DETROIT DIESEL

SERIES 60® 2007 Service Information

NUMBER: 08 60-9 **S.M. REF.:** 2.9 **ENGINE:** EPA07 Series 60 **DATE:** November 2008

SUBJECT: DDEC VI MOTOR CONTROL MODULE

Figure 1 Tie Straps on Harness

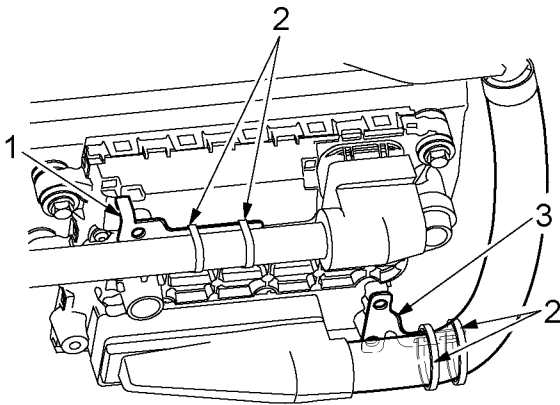
DDEC VI Motor Control Module (MCM) fuel cooler has been removed from the EPA07 Series 60 engine effective October 27, 2008.

1. Shut off engine and apply the parking brake, chock the wheels, disconnect vehicle battery power, and perform any other applicable safety steps.
2. Cut the tie straps (2) that attach harness to the bracket(s) (1, 3). See Figure 3

Figure 2 Harness Latches and Bolts

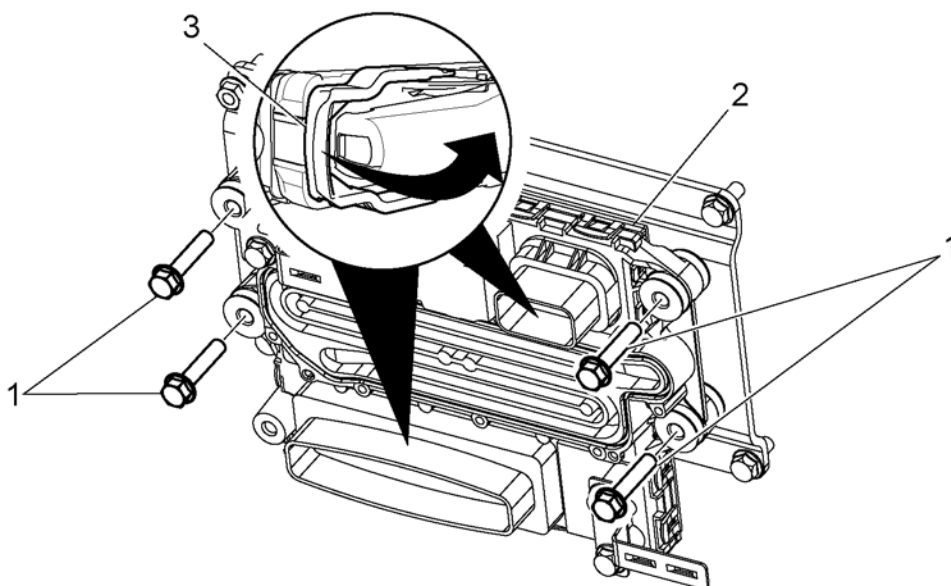
3. Release the harness connector latches (3) removing the 120 and 21-pin connectors from the MCM (2). See Figure 2.

4. Remove the four bolts (1) holding the MCM (2) to the engine. Remove the MCM (2) from engine.

Figure 3 Tie Straps on Harness

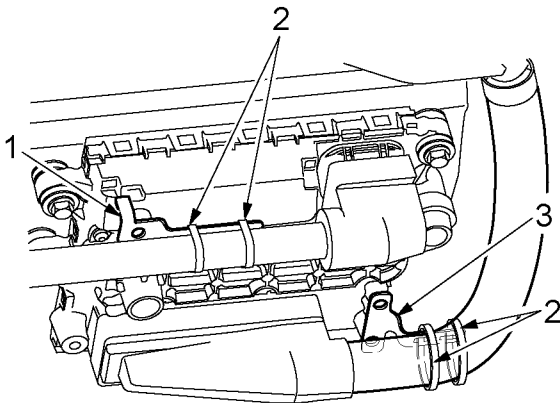
1. Mount the MCM to the engine.
2. Install the MCM to the engine with four bolts. Torque the MCM to engine bolts to 34 N·m (25 lb·ft).
3. Connect the 120 and 21-pin engine harness connectors to the MCM. Close and lock latch on the connectors.
4. Install tie straps (2) onto harness. See Figure 3.
